ROUTE 90 IMPROVEMENTS STUDY

Phase 3 Public Engagement Summary

Objective: Provide three lanes in each direction

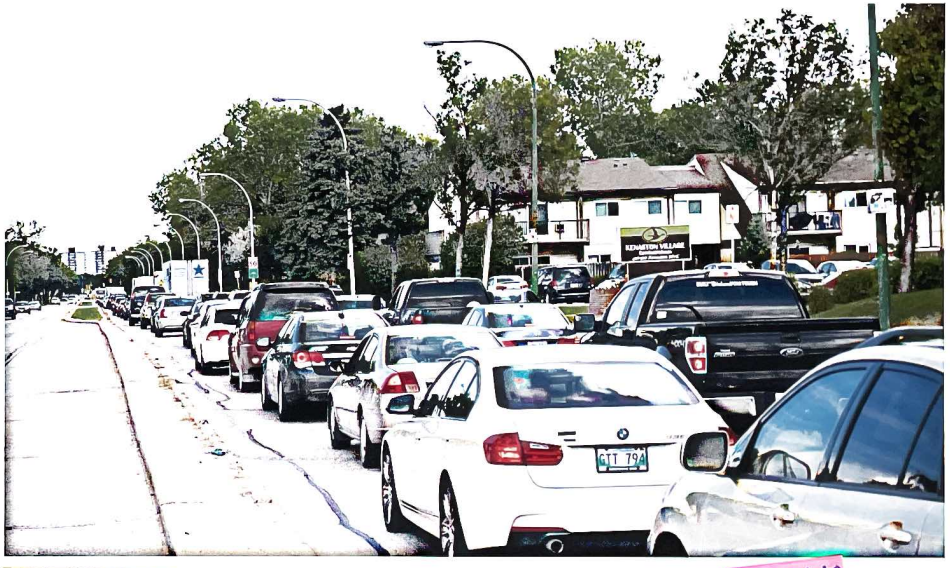
Province of Manitoba is already planning a freeway. Highway expansion - Why spend so much money for a measly 3,000 trucks? √√

Too many trucks on Rte 90. They need to be diverted to the Perimeter unless serving the immediate area
